On the following pages is an excerpt from the “Information needed for Registration of SABIA X1-XP Materials Analyzer” taken from your letter of June 19, 2013. In each section, I have repeated the question or comment, and have attempted to provide the required information beneath each section.

SABIA Inc 's Application dated March 29. 2013  
Information Needed for  
Registration of SABIA X1.XP Materials Analyzer

Detail photo of source housing of SABIA X-1 analyzer, showing source holders installed into one source location.

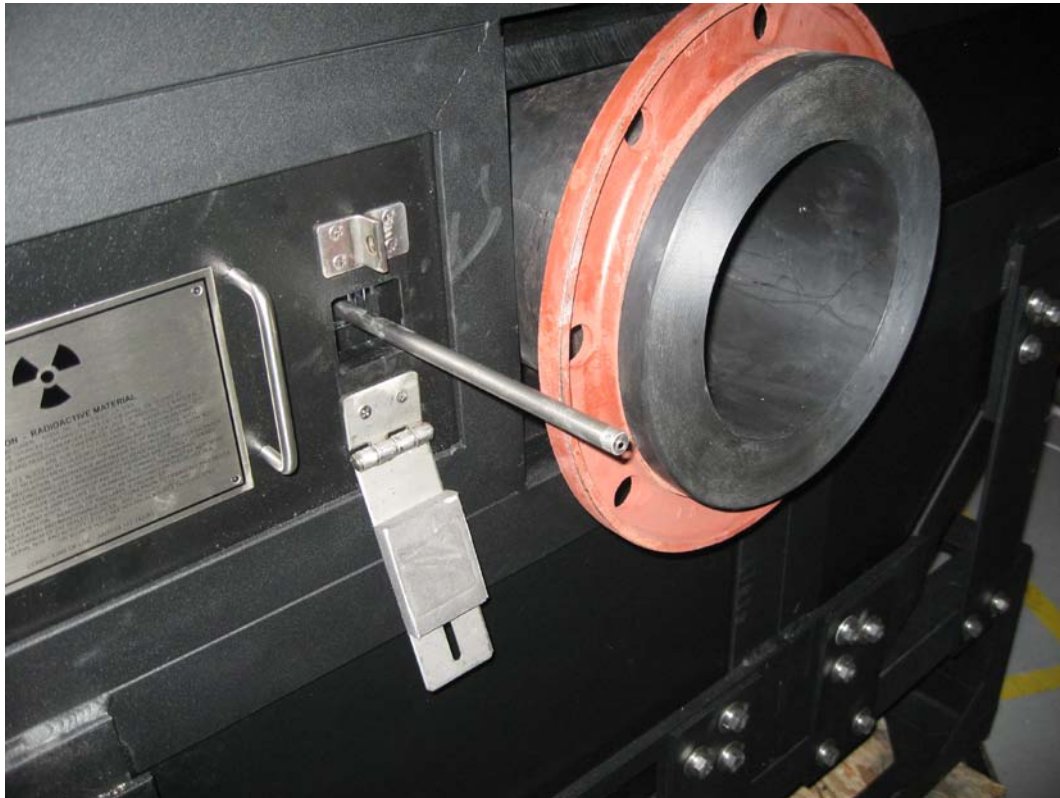
- 1.2.1 The drawing provided on Page 16 does not indicate how the source will be secured in the source holder Please provide a detailed engineering drawing for the source holder and specify how the source will be mounted.

- 1.2.2 Provide drawings that illustrate how four individual sources are to be mounted in the source holder (Page 4, Paragraph 1).

**Additional details are provided in the attached color photos, showing details of the source holder, source housing, locking mechanism, and security lock.**

**Please see attached color photos, illustrating the mounting of four individual source holders in the source housing.**
